REPORT HI-2114830

Proposed Revision 10C

CHAPTER 3.I: STRUCTURAL EVALUATION

Figure 3.I.3.1: Stress Intensity in MPC Enclosure Vessel – Normal Condition

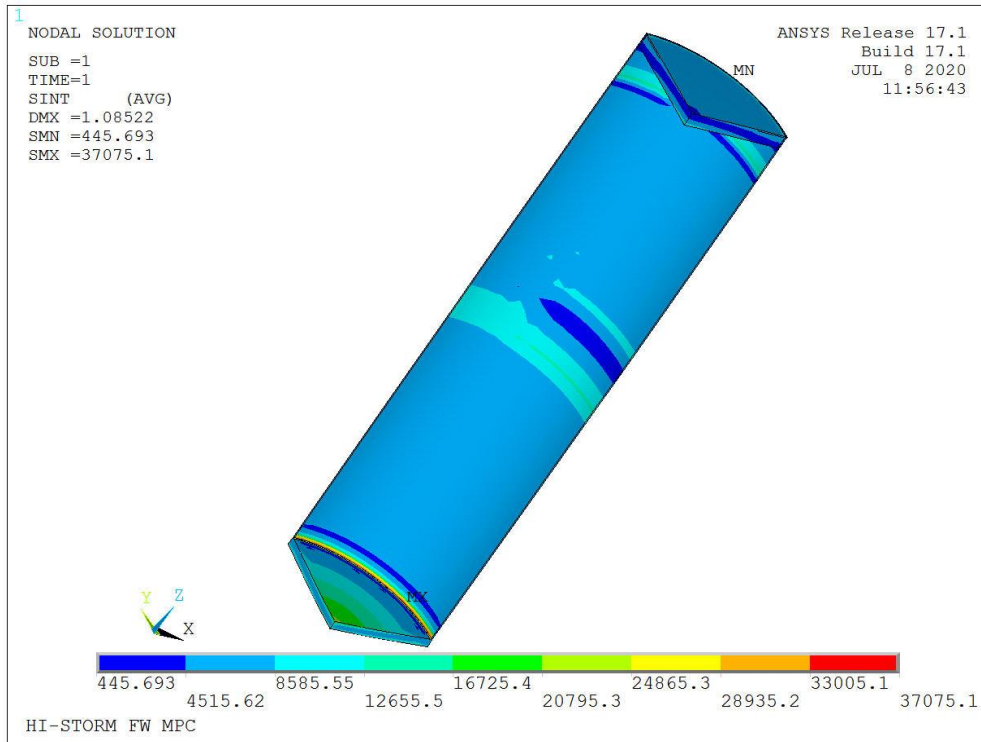
Using the ANSYS finite element model of **the MPC** described in **Paragraphs 3.1.3.2 and 3.4.3.2**, two separate analyses **for normal and off-normal conditions** are added to demonstrate structural integrity **of the confinement boundary in Supplement 1 of [3.4.13]** as described below. **The analyses under handling, design, short-term normal and accident conditions are not explicitly performed for the Version UVH system as they are bounded by those presented in Paragraph 3.4.3.2 and Subparagraphs 3.4.4.1.5 and 3.4.4.1.6, respectively.**

- i) **Normal Condition:** The long-term normal condition internal pressure limit in Table 2.2.1 is applied to MPC lid, shell and baseplate along with **a conservatively bounding** temperature contour obtained from normal condition thermal analysis in **Chapter 4.I Section 4.I.4**. The primary and secondary stresses in MPC lid, shell and baseplate are then compared against ASME NB Level A stress limits obtained at bounding component temperatures. **The analysis methodology and acceptance criteria are the same as those described in Subparagraph 3.4.4.1.5 for the MPC confinement boundary evaluation under normal condition. Additional analysis details are presented in Case 7 of Supplement 1 of [3.4.13]. The key results are presented in Table 3.I.3.2 and Figure 3.I.3.1 which demonstrate that all safety factors are greater than 1.0. It is demonstrated in Supplement 1 of [3.4.13] that all safety factors are greater than 1.0.**

Figure 3.I.3.2: Stress Intensity in MPC Enclosure Vessel – Off-Normal Condition

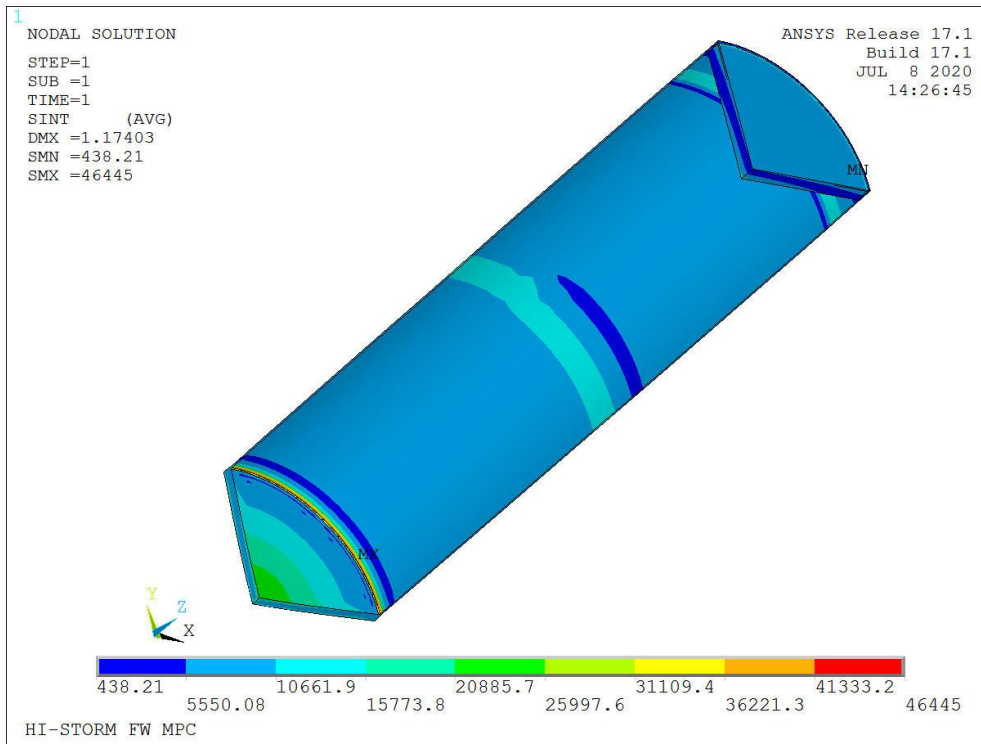
- ii) **Off-normal Condition:** The off-normal condition internal pressure limit in Table 2.2.1 is applied to MPC lid, shell and baseplate along with **a conservatively bounding** temperature contour **obtained from based on the** off-normal condition thermal analysis in **Chapter 4.I Subsection 4.I.6.1**. The primary and secondary stresses in MPC lid, shell and baseplate are then compared against ASME NB Level B stress limits obtained at bounding component temperatures. **The analysis**

methodology and acceptance criteria are the same as those described in Subparagraph 3.4.4.1.5 for the MPC confinement boundary evaluation under off-normal condition. Additional analysis details are presented in Case 8 of Supplement 1 of [3.4.13]. The key results are presented in Table 3.I.3.3 and Figure 3.I.3.2 which demonstrate that all safety factors are greater than 1.0. It is demonstrated in Supplement 1 of [3.4.13] that all safety factors are greater than 1.0.
